Appl. No. : 09/379,704
Filed : August 24, 1999

COMMENTS

AMENDMENTS TO THE DRAWINGS

FIG. 5

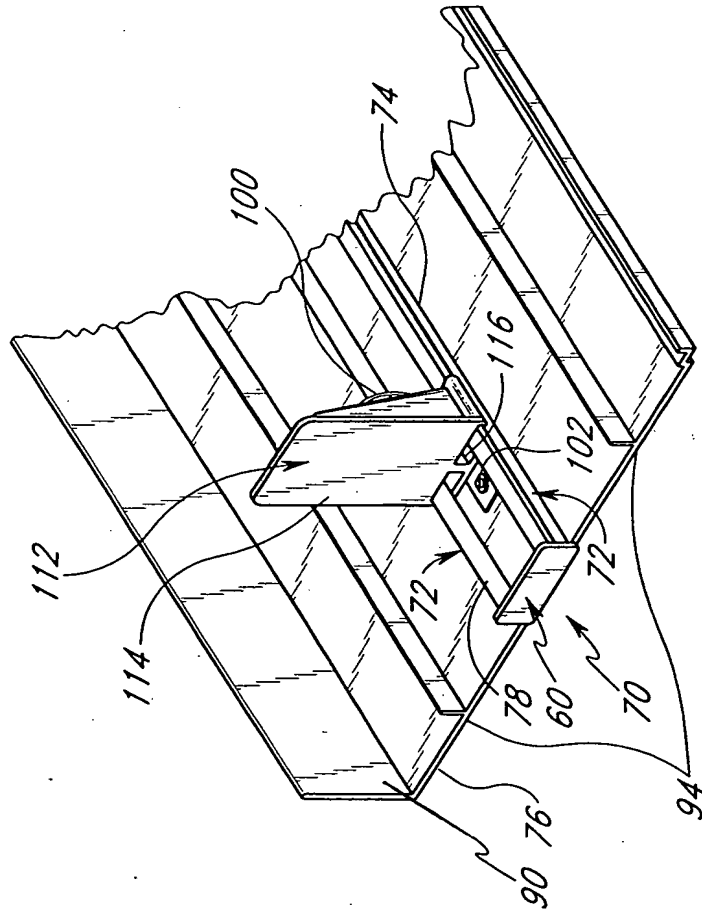
With respect to Figure 5, the lead line extending from the reference numeral 90 has been extended and the arrow head has been removed. Applicant submits, however, that reference numeral 76 is properly shown in the figure.

FIG. 7

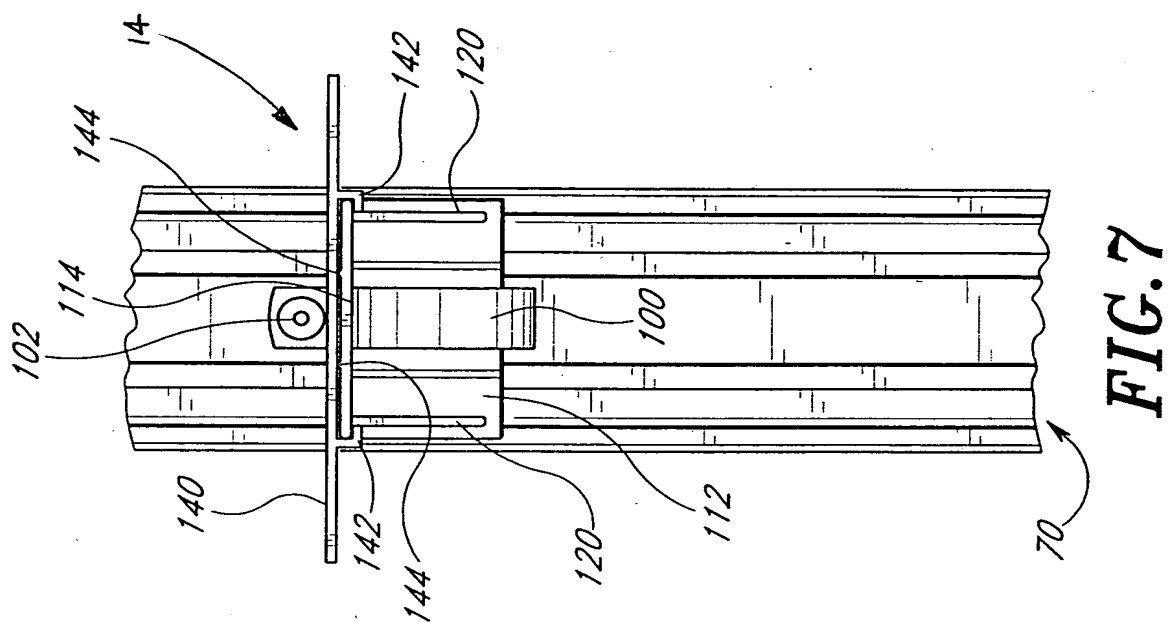
With respect to Figures 6-8, the reference numeral 14 has been added to each of these figures for clarity.
